SERVICE BULLETIN

BULLETIN NO: 13-007

TITLE: Grinding Head Accumulator Pre-Charge Pressure Change

PRODUCT SERIES / MODEL: PGM96 Series C - China Rail Corporate (Formally MOR)

FIGURE 1
CHECKING AND CHARGING ACCUMULATORS

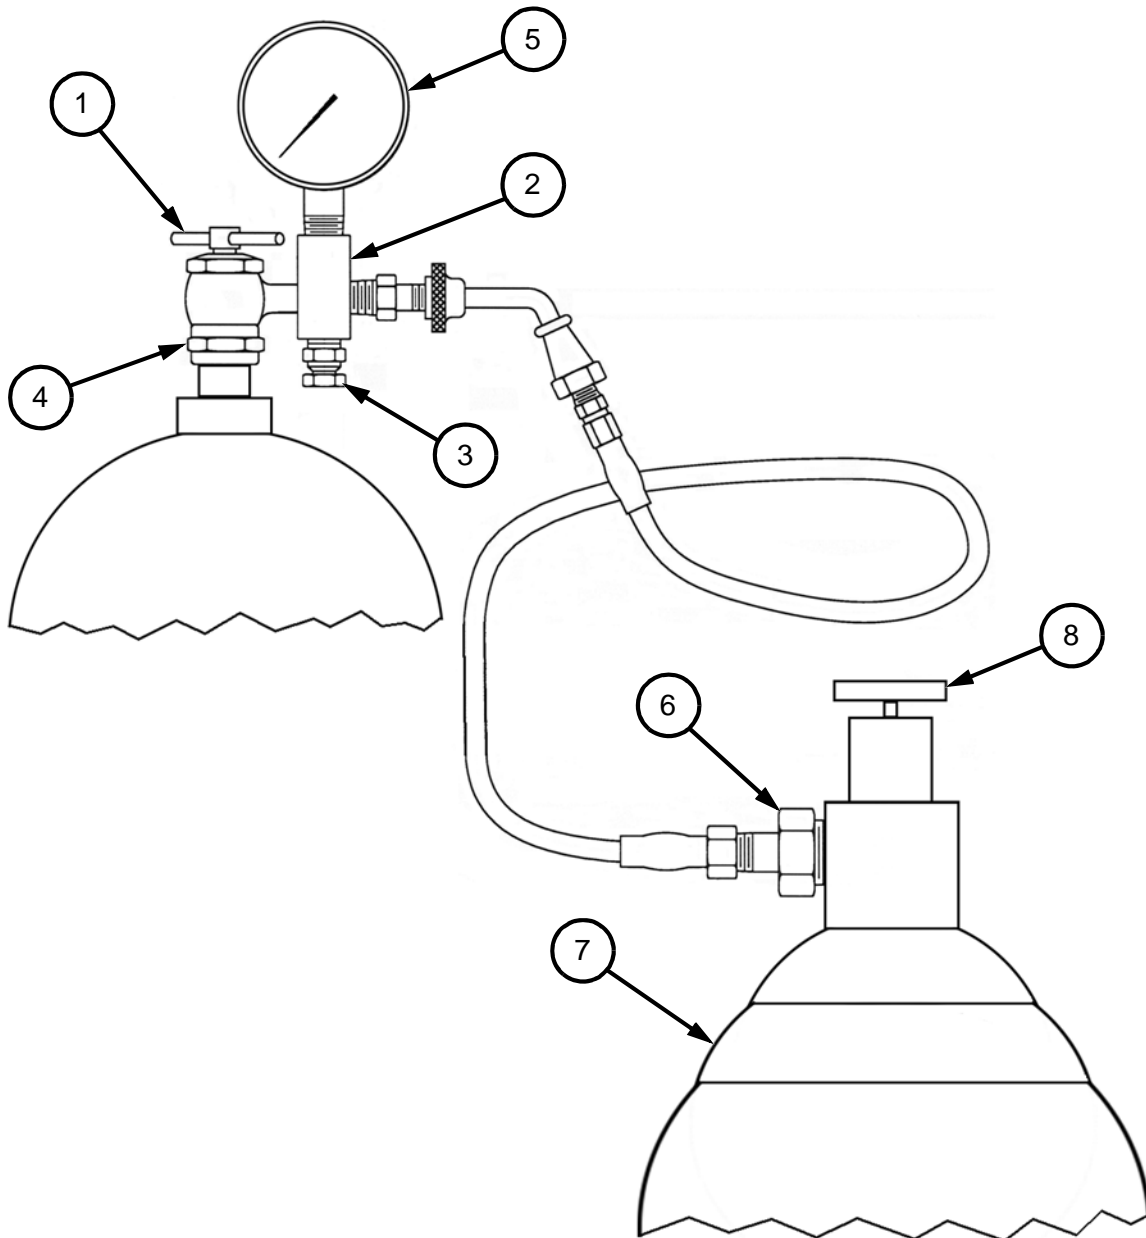
Checking And Charging Accumulators - See Figure 1

3. All existing and new accumulators are pre-charged to 72.4 - 79.3 bar (1050 - 1150 PSI). The accumulators pre-charged pressure must be reduced to 55.2 - 58.6 bar (800 - 850 PSI). All hydraulic pressure must be relieved from the system before charging the accumulators. Use Harsco Rail nitrogen charging kit #152783-1 to check and charge the accumulators.

Checking And Charging Accumulators - See Figure 1

4. Remove gas valve guard and gas valve cap from the accumulator.
5. Rotate the gas chuck "T" Handle (1) counter-clockwise all of the way out before attaching charging assembly (2) to the accumulator gas valve.

6. Make sure the bleed valve (3) on the charging assembly is closed.
7. Attach swivel nut (4) to the gas valve and tighten to 1.13 - 1.69 N-m (10-15 lb-in).

8. Turn gas chuck "T" Handle (1) until the gauge (5) starts showing the pressure in the accumulator. Do not turn the "T" Handle all the way down, as it will damage the valve core.

9. If the pressure indicated on the gauge is the desired pressure, 55.2 - 58.6 bar (800 - 850 PSI), for the accumulator being checked, go to Step 13. If not, the accumulator will need to be charged or the charge reduced.

10. When charging the accumulator, use only nitrogen that is free of any contaminants. Connect charging hose end (6) to the nitrogen bottle (7).
11. Crack open nitrogen bottle valve (8) and slowly add nitrogen to the accumulator. Close the valve when gauge indicates desired charge. Let the charge set for 10 to 15 minutes. This will allow the gas temperature to stabilize.

12. If the desired charge is exceeded, close nitrogen bottle valve, then slowly open bleed valve (3). Do not reduce charge by depressing valve core with a foreign object. High pressure may rupture rubber valve seat.

13. When finished checking or charging the accumulator, turn "T" Handle (1) all the way out and then open bleed valve (3).
14. Remove charging hose from nitrogen bottle. Remove charging assembly (2) from the accumulator.
15. Check for charge leak at the valve core using a common leak reactant.
16. Replace gas valve cap and tighten to 1.13 - 1.69 N-m (10-15 lb-in). Gas valve cap serves as a secondary seal. Replace accumulator gas valve guard cap.
